CALL NO. 104
CONTRACT ID NO. 161032
ADDENDUM # 1

Subject: Jefferson County, STP BRO 2641 (182)
Letting May 27, 2016

- (1) Revised - Plan Sheets - T1 & T6
- (2) Revised - Bid Items - Pages 137-139 of 139

LIGHTING PLAN SHEET
I-64 EB @ I-256 EB RAMP

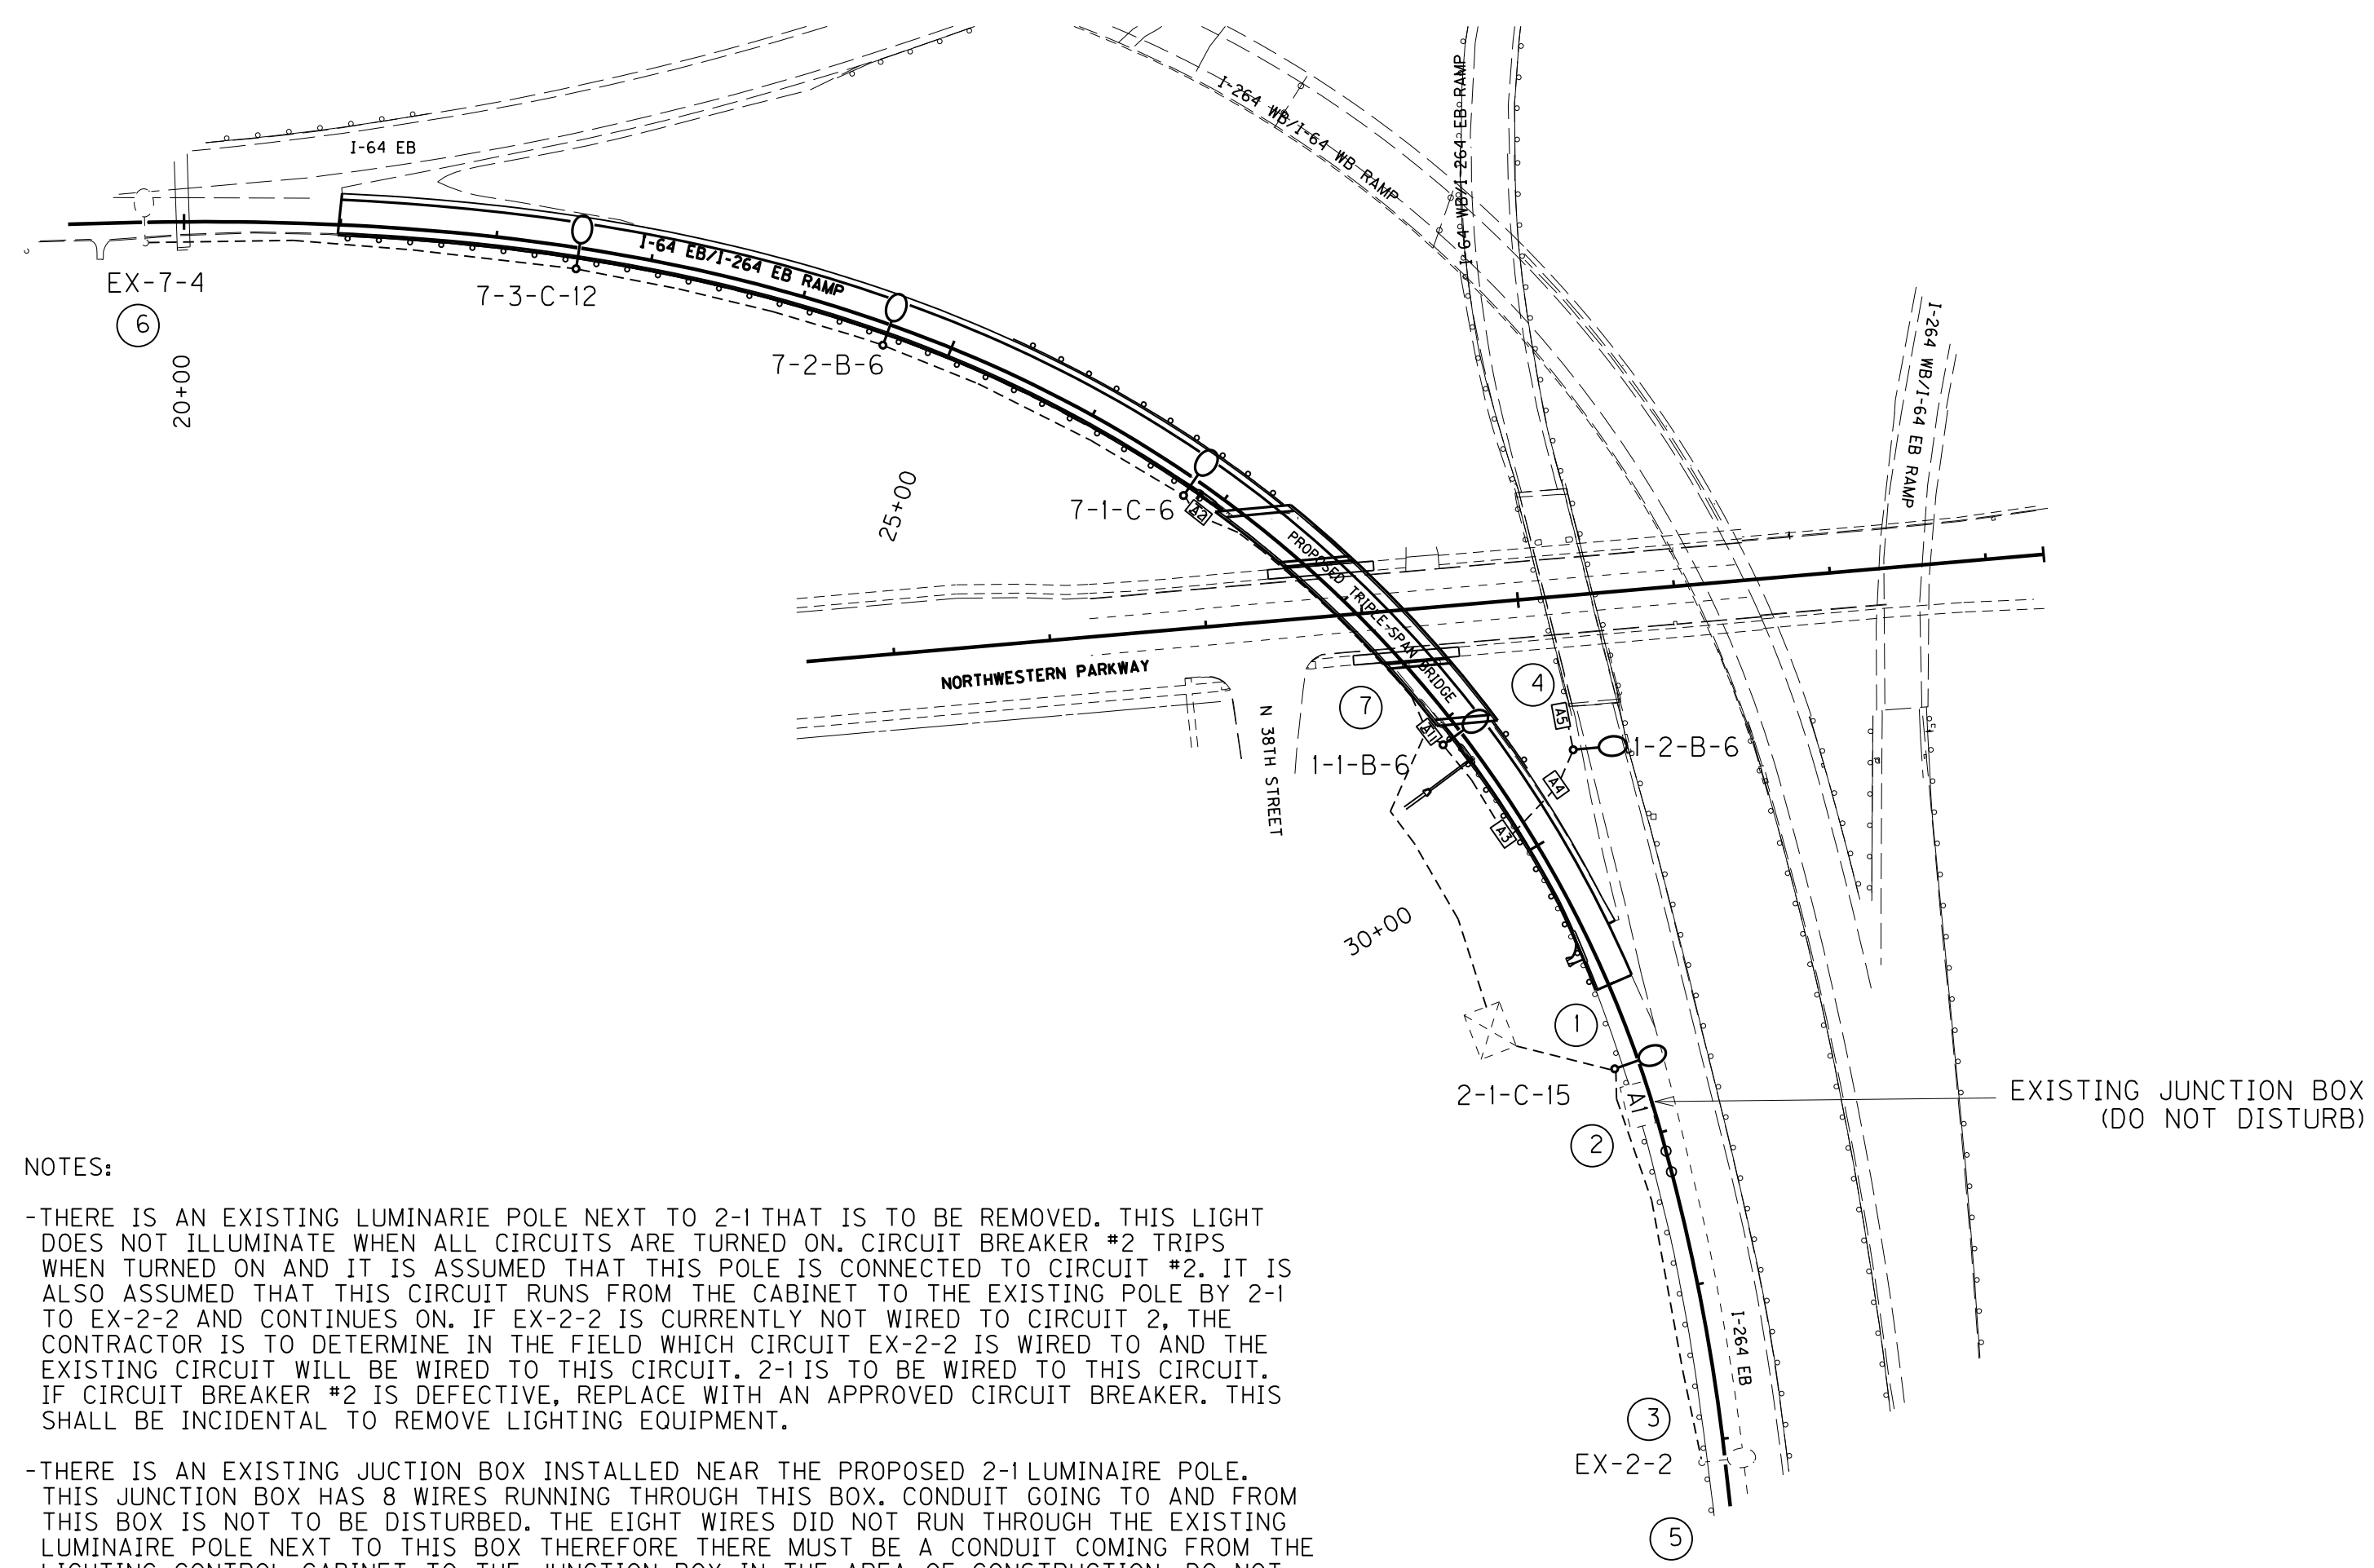
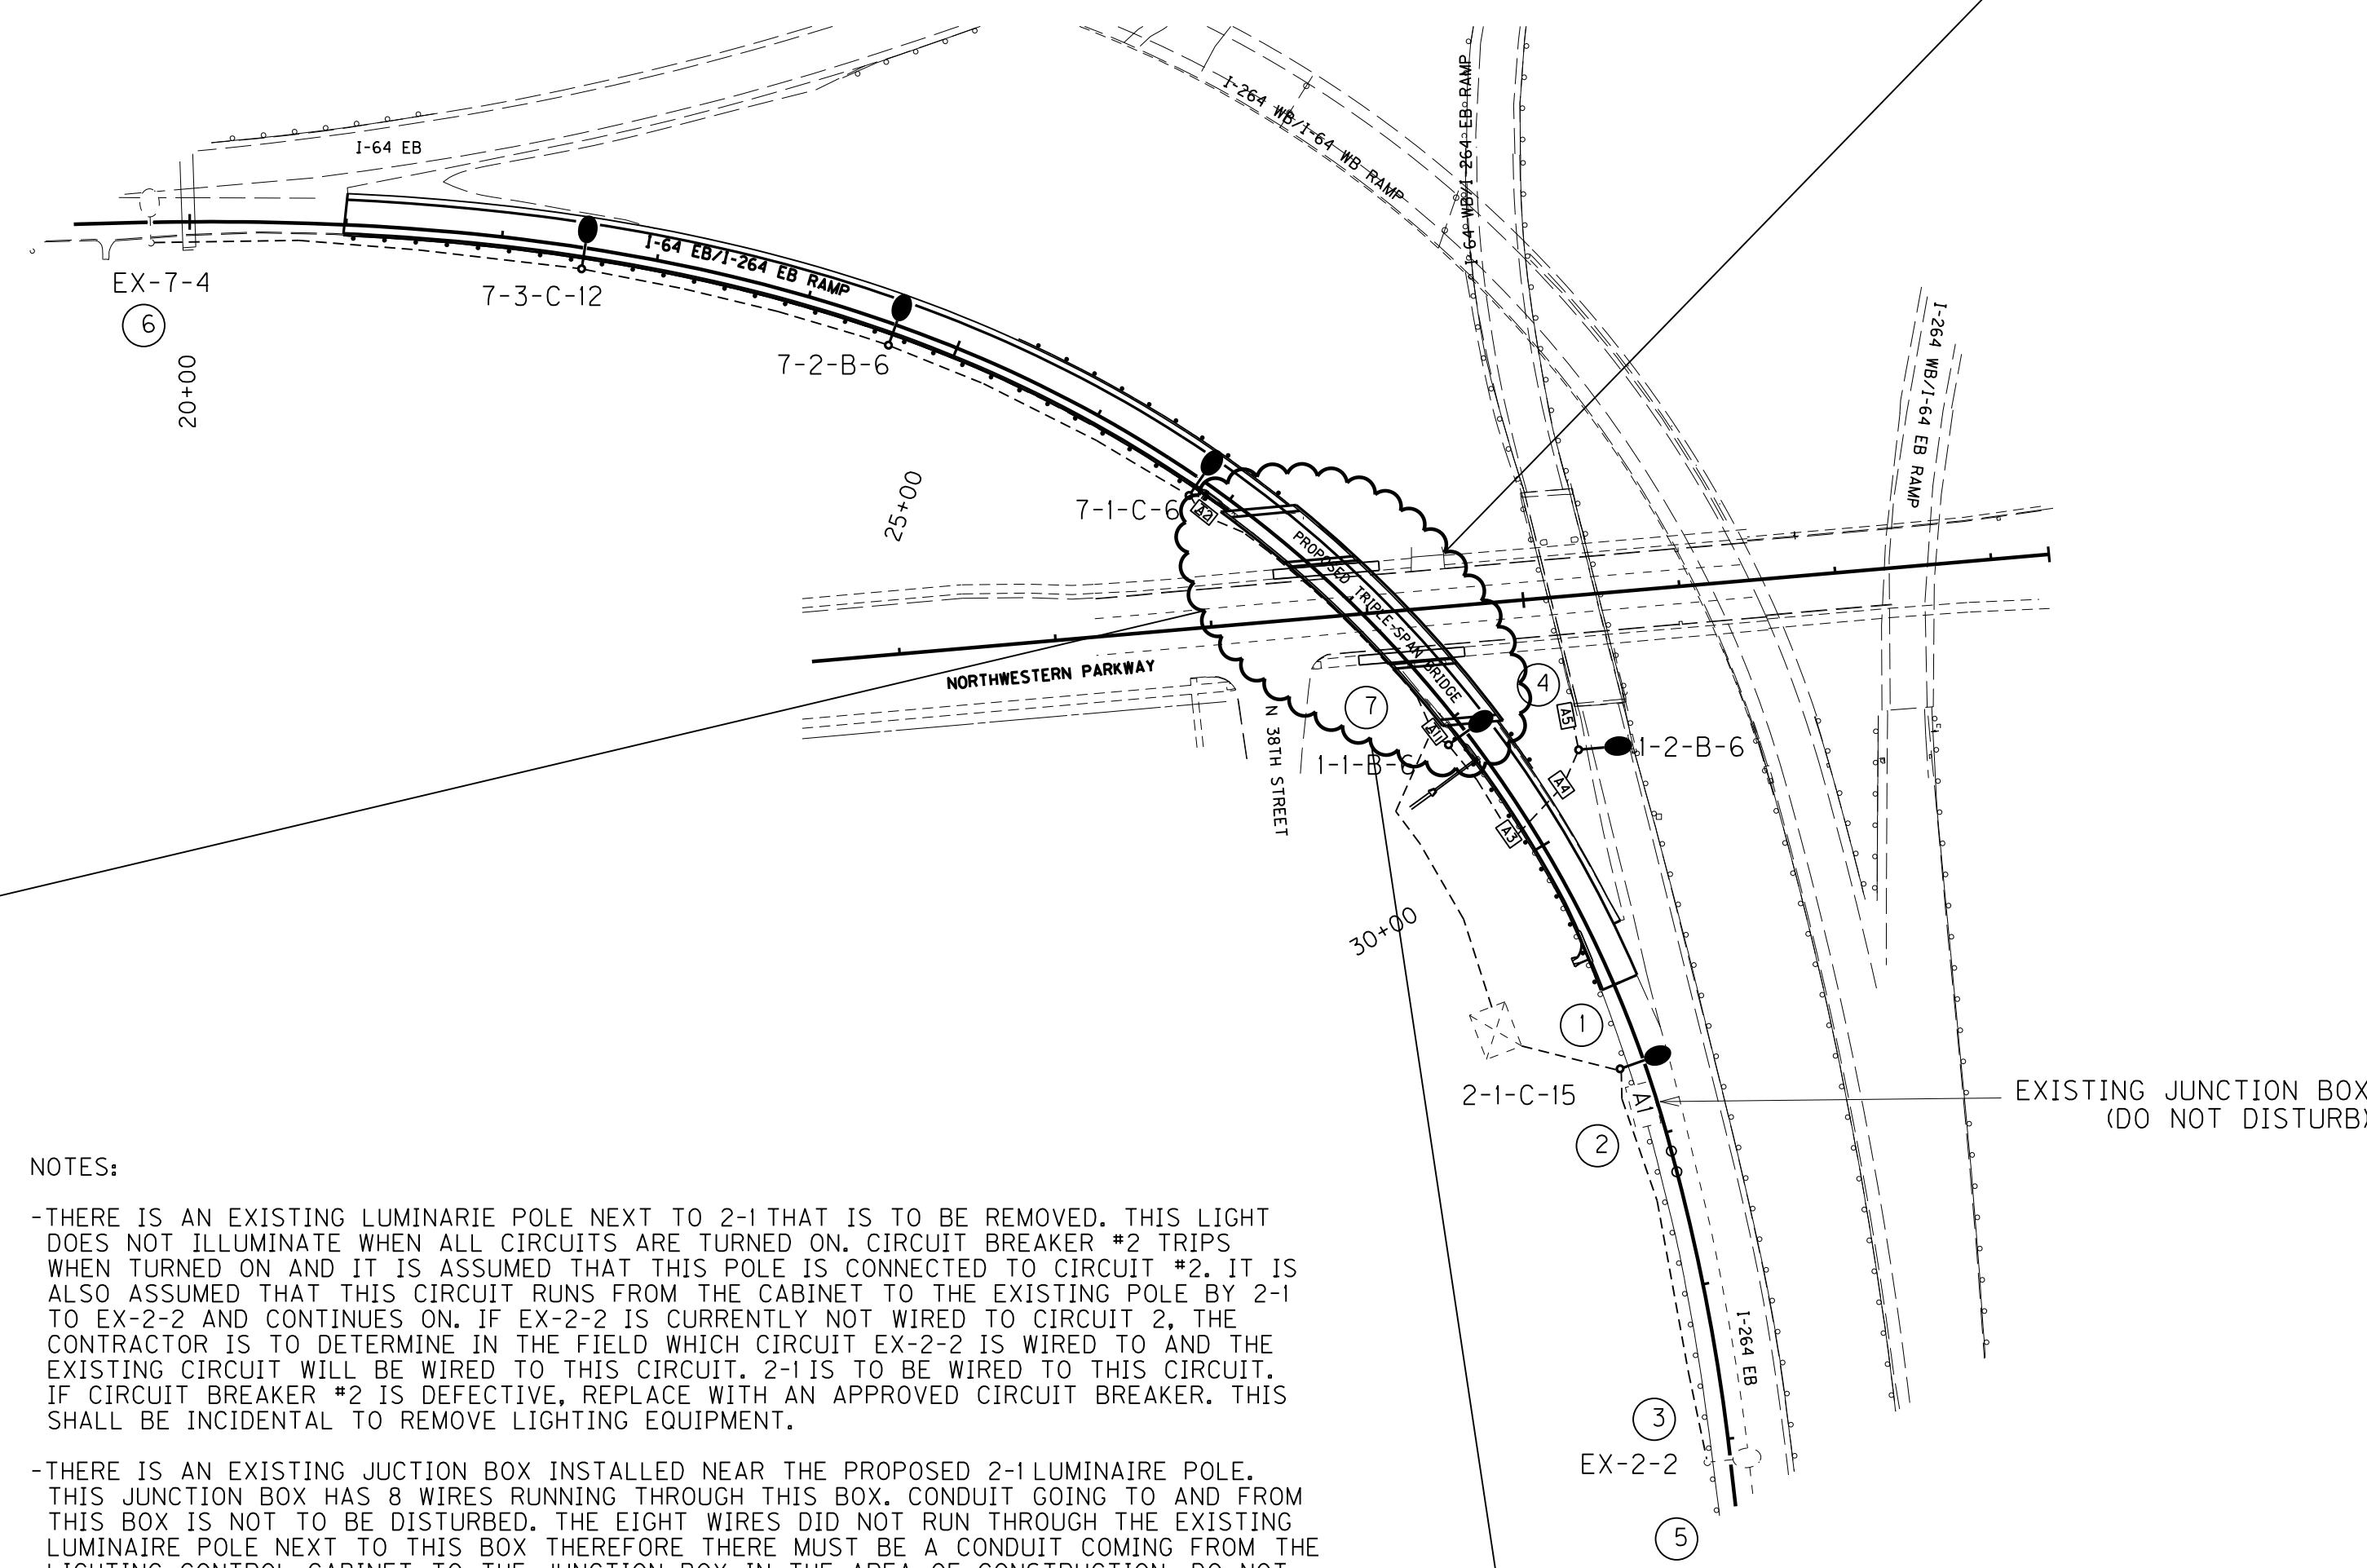
JUNCTION BOXES "A1 & A2" ALONG WITH CONDUIT ALONG BRIDGE ARE A PART OF THE STRUCTURAL PLANS & ITS QUANTITIES.

- ⑦ -INSTALL 2" CONDUIT ALONG SIDE OF BRIDGE. CONDUIT SHALL BE CONNECTED TO BRIDGE EVERY 4 FEET. CONTRACTOR SHALL GET APPROVAL FOR TYPE OF CONNECTOR BEING USED. TRANSITION TO AND FROM BRIDGE THROUGH JUNCTION BOX JBA1 AND JBA2.

WIRING SCHEDULE			
CKT #1	FROM	TO	CONDUIT SIZE
CKT #1	CONTROLLER	JBA1-OTHER	2" RS
	JBA1-OTHER	1-1	2" RS
	1-1	JBA5 (THRU JBA3, JBA4, 1-2)	2" RS
CKT #2	CONTROLLER	2-1	1 1/4" RS
	2-1	EX-2-2	1 1/4" RS
CKT #X-1	CONTROLLER	JBA5 (THRU JBA1-OTHER, 1-1, JBA3, JBA4, 1-2)	2" RS
CKT #7	CONTROLLER	JBA1-OTHER	2" RS
	JBA1-OTHER	JBA2-OTHER	2" RS BY OTHERS
	JBA2-OTHER	EX-7-4 (THRU 7-1, 7-2, 7-3)	1 1/4" RS
